**Service Bulletins
January 1979 to
September 1986 inclusive**

**Rolls-Royce Silver Shadow
Long Wheelbase,
Corniche and Camargue
Bentley T Series and Corniche
Rolls-Royce Silver Shadow II
and Silver Wraith II
Bentley T2**

ALL ROLLS-ROYCE FRANCHISE HOLDERS
SERVICE BULLETIN INDEX FOR TSD 4318

Fig. 1

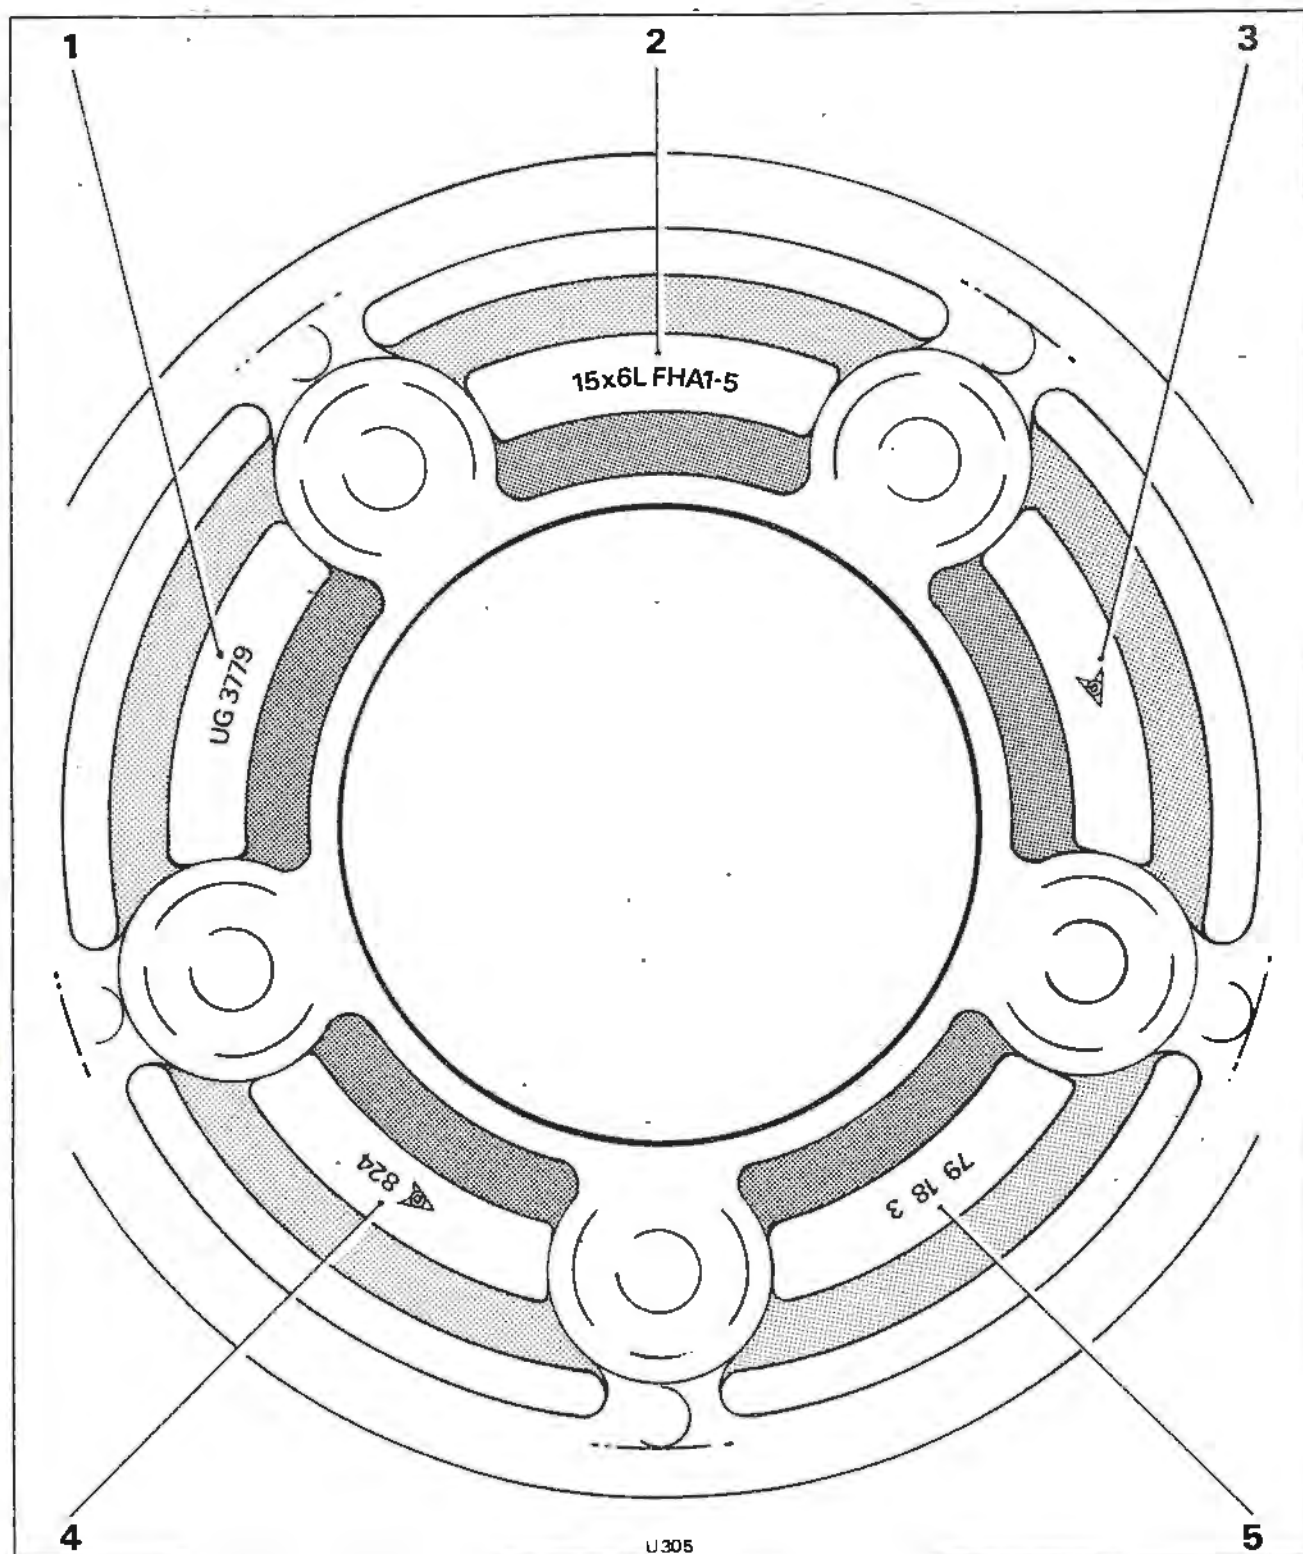
New wheels can be identified by inspecting the stud pitch circle diameter of the wheel for identification marks as shown in Figure 1. The earlier type of wheel did not have these marks.
